## Concept Report Form

<b>Project Name</b>	SR 87 - Bridge over Drainage Ditch (TMA)									
<b>PIN</b>	134856.00									
<b>Route Information</b>	<b>Route</b>	<b>NHS (Y/N)</b>	<b>Functional Class</b>			<b>City</b>		<b>County</b>		
	SR 87	No	Urban Major Collector					Lauderdale		
<b>Project Information</b>	<b>Begin Log Mile</b>	<b>End Log Mile</b>	<b>AADT<sup>1</sup></b>	<b>Design Hour Vol. (DHV)<sup>1</sup></b>	<b>Truck %<sup>1</sup></b>	<b>Design Speed (MPH)</b>	<b>Posted Speed (MPH)</b>	<b>Base Year</b>	<b>Design Year</b>

## 0SD2 Environmental Desktop Review Form

<b>PIN</b>	134856.00
<b>Project Number (if available)</b>	
<b>County</b>	Lauderdale
<b>Route</b>	SR87
<b>Termini</b>	Bridge over Drainage Ditch (TMA)
<b>Type of Document</b>	
<b>Date ENV DIV Comments are Due</b>	10.10.24 by noon

## ENVIRONMENTAL TECHNICAL STUDY AREA

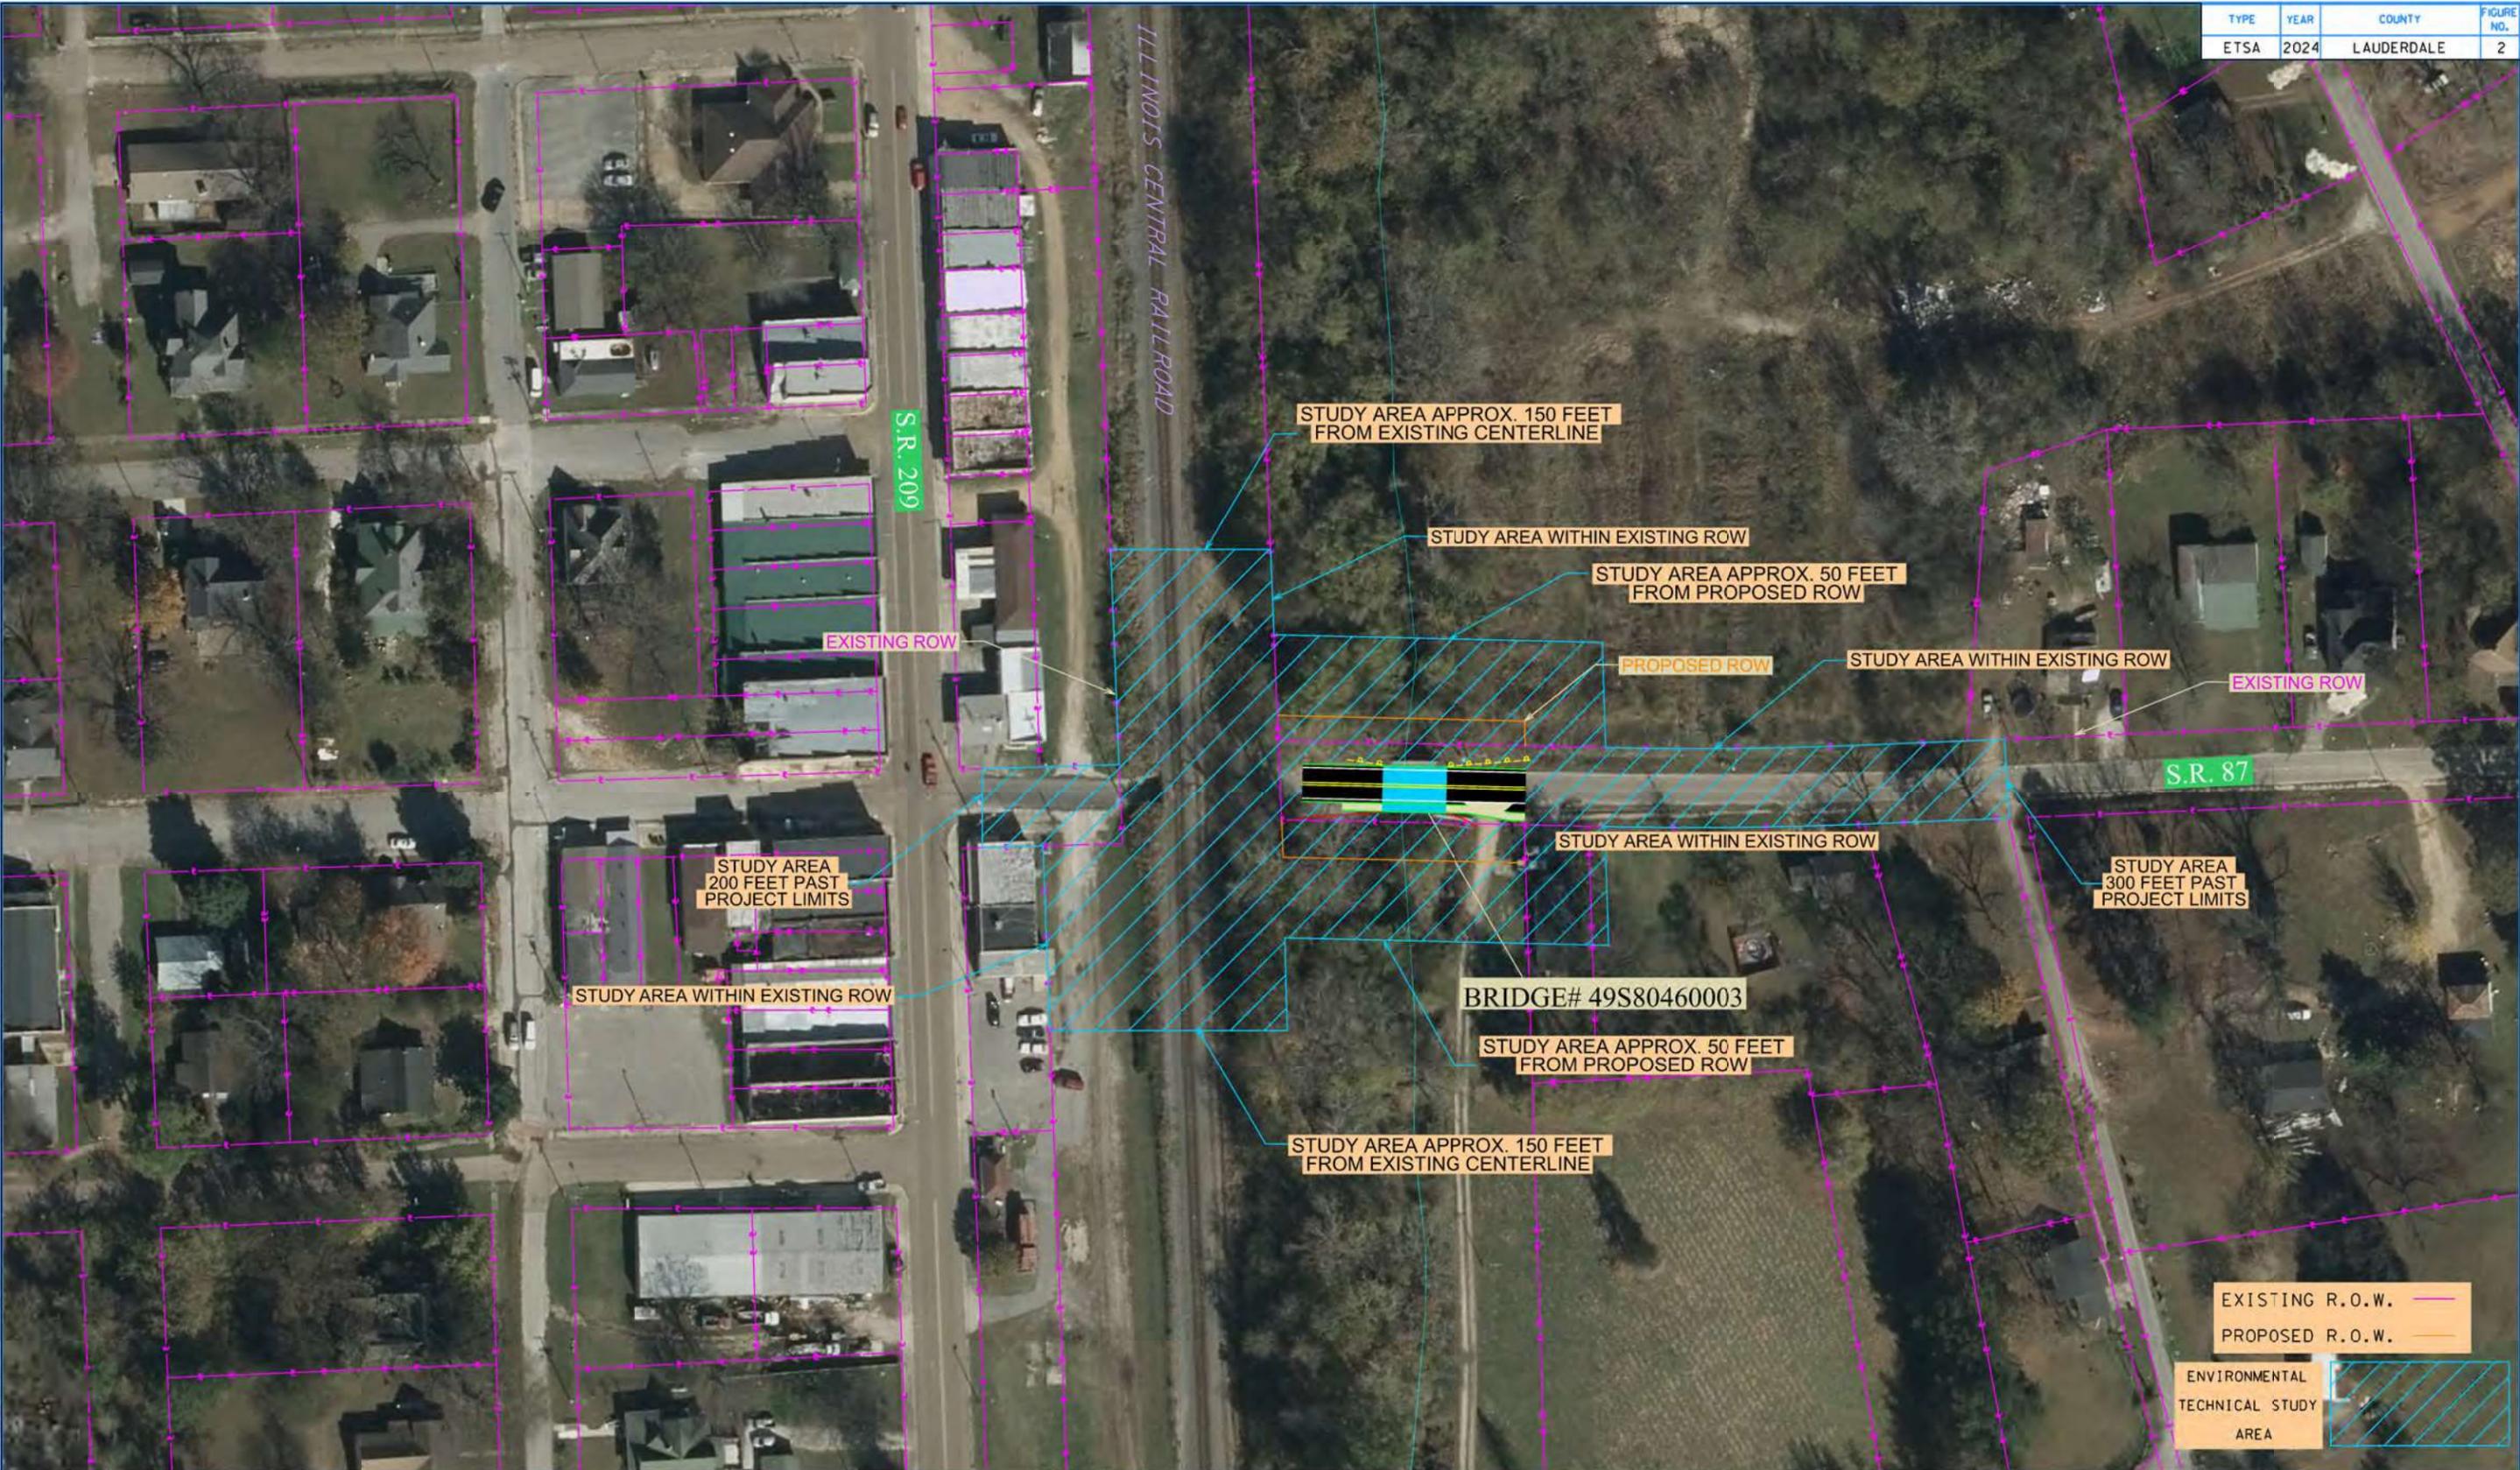
The ETSA boundary encroaches on a structure (Henning City Hall) on the west end of the project. The structure appears to be encroaching into state ROW on the north side of the building and the railroad's ROW on the east side of the building, based on the property lines.

I'm not sure why the boundary is so expanded on the railroad track? What is the purpose of the large boundary around the railroad? It doesn't seem close to the subject bridge and I wouldn't expect this kind of project to result in relocations, but I'm uncertain what activities might be needed on the west side of the project.
